CLARK COUNTY
WASHINGTON

DEPARTMENT OF COMMUNITY DEVELOPMENT
BUILDING SAFETY DIVISION

DATE: February 11, 2008

RE: Camas Court House

Fig. 604.5.2
 Rear Wall Grab Bar for Water Closet

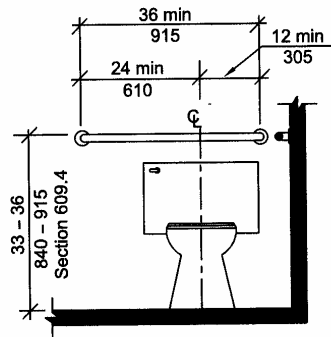
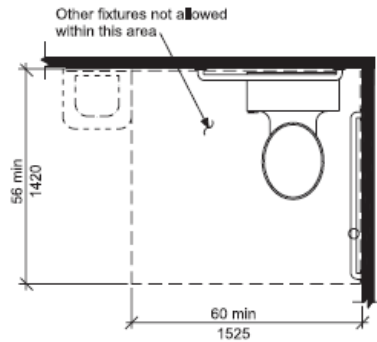
Item # 21
 Issue: Rear Wall Grab Bar Length and Placement
 Issue: Size of Water Closet for Clearance
 Location: Accessible Restroom
 Code: ANSI A117.1-2003 Fig. 604.5.2

Notes: The current rear wall grab bar is 24" in length and should be a minimum of 36 inches. Also, the bar should be off-centered as indicated in diagram above.

Extending width of water closet will not be possible unless a renovation is conducted.
